MISSISSIPPI POWER & LIGHT COMPANY

SUBJECT: Grand Gulf Nuclear Station
Unit 1
Docket No. 50-416
License No. NPF-29
File: 0260/0840/L-860.0
Response to Request for Additional
Information on PCOL-85/11
AECM-85/0341

LOW PRESSURE INTERLOCK ECCS PERFORMANCE ANALYSIS

GRAND GULF FSAR RECOMMENDED CHANGES TO INCORPORATE A PRESSURE
PERMISSIVE ON THE LOW PRESSURE ECCS INJECTION VALVES

FIGURE 6.3-14

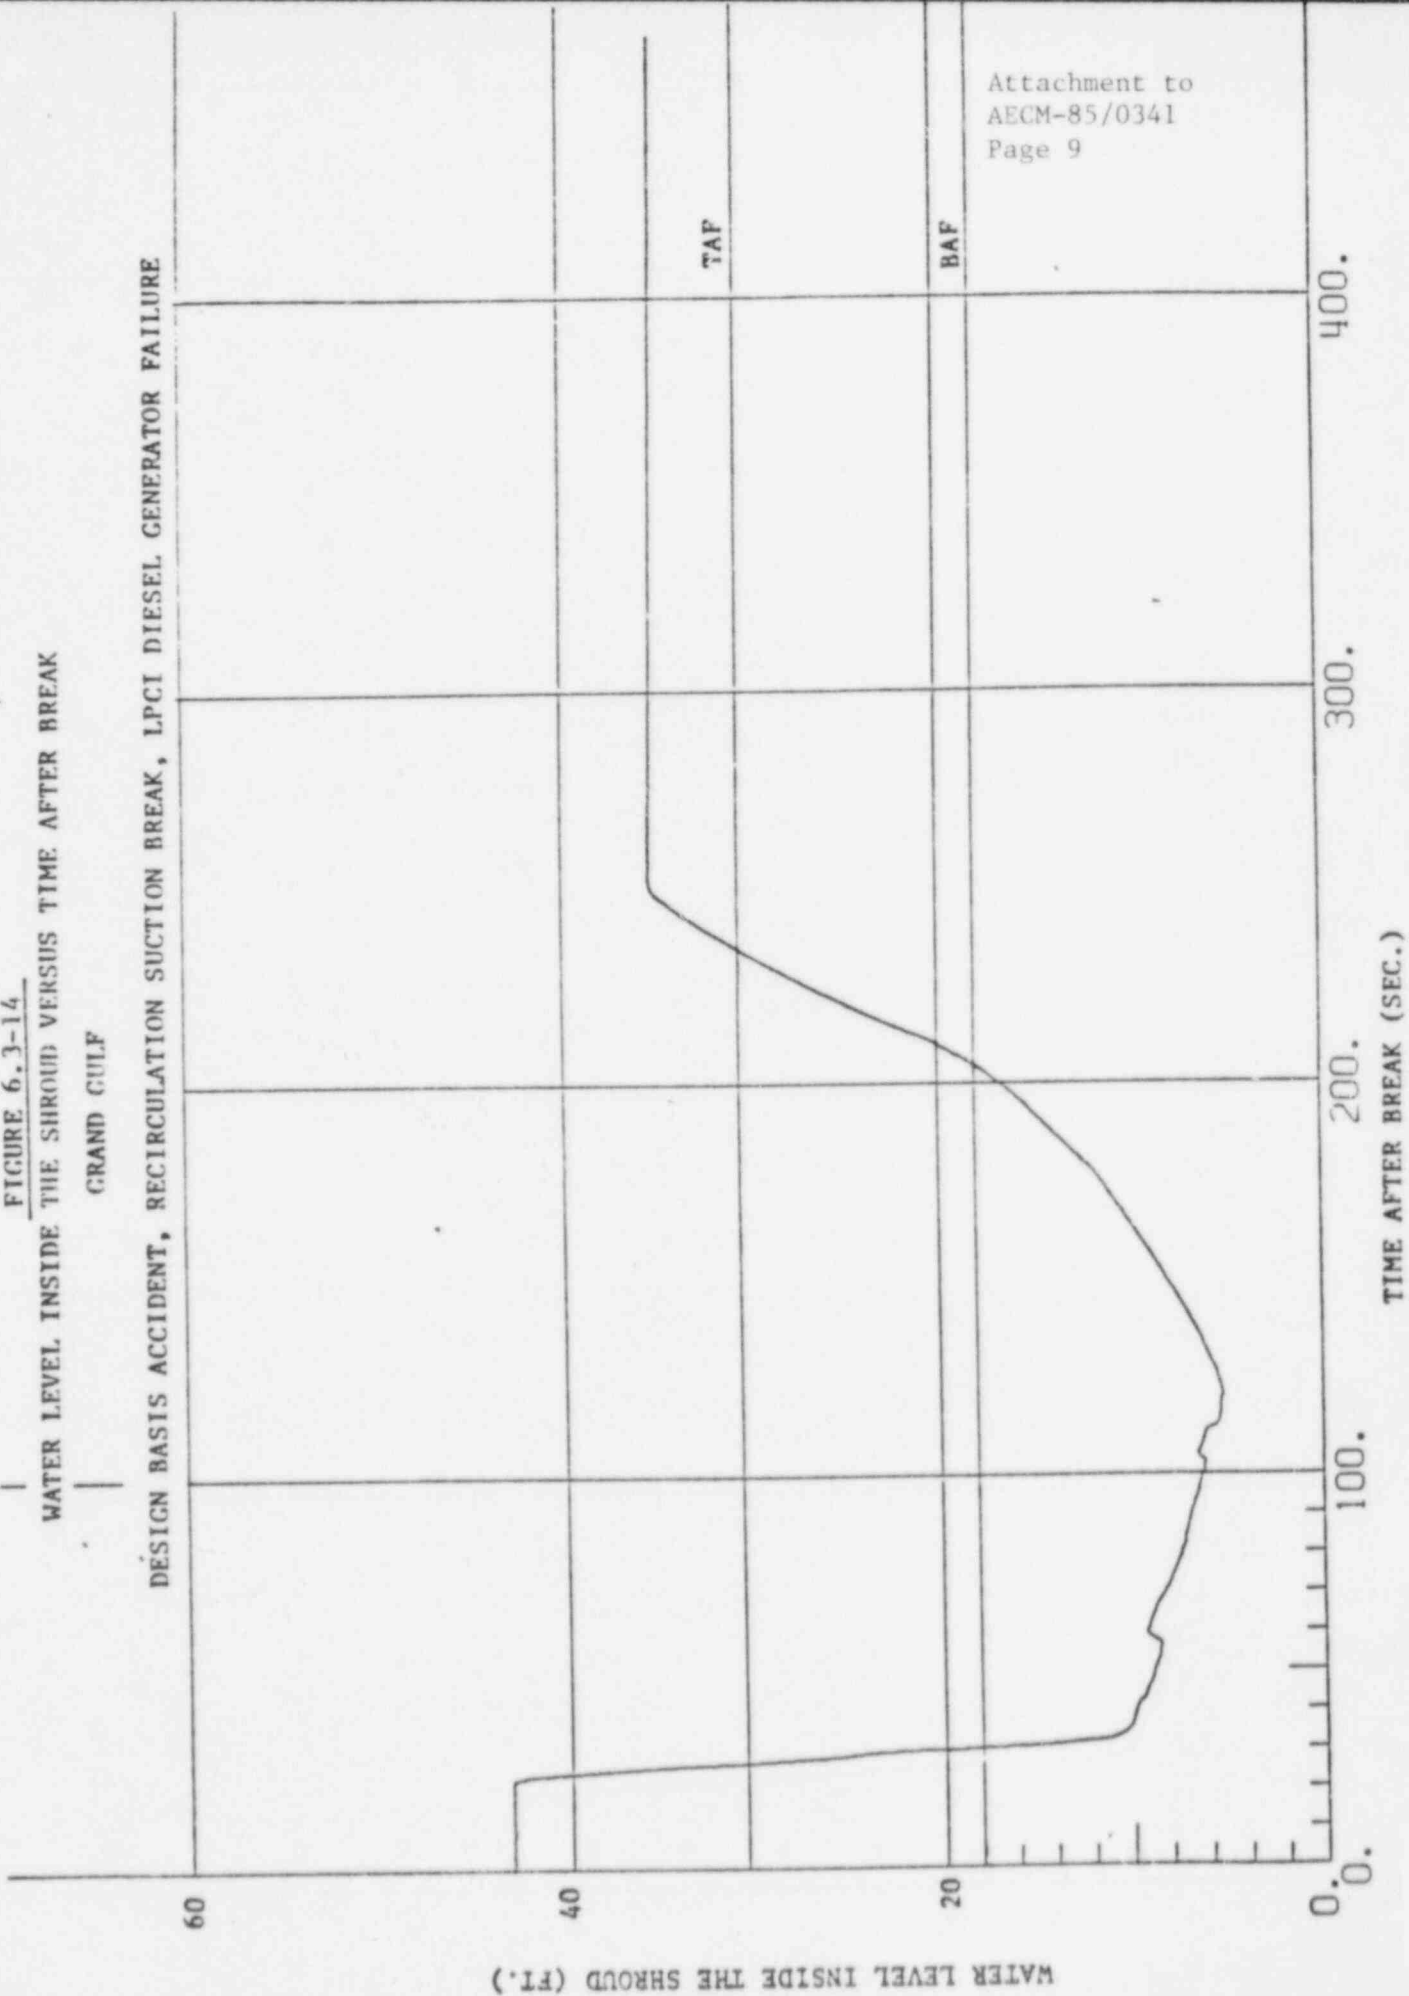
To document the effect on the LOCA analysis of adding the low pressure ECCS pressure permissive, attached are some recommended changes for FSAR Tables 6.3-1, 6.3-2, 6.3-3 and 6.3-6. Revised copies of FSAR Figures 6.3-14, 6.3-15 and 6.3-16 are also attached which show the water level, pressure and peak cladding temperature response with the addition of the injection valve pressure permissive. These recommended changes to the FSAR will be incorporated, if applicable, at the appropriate annual update.
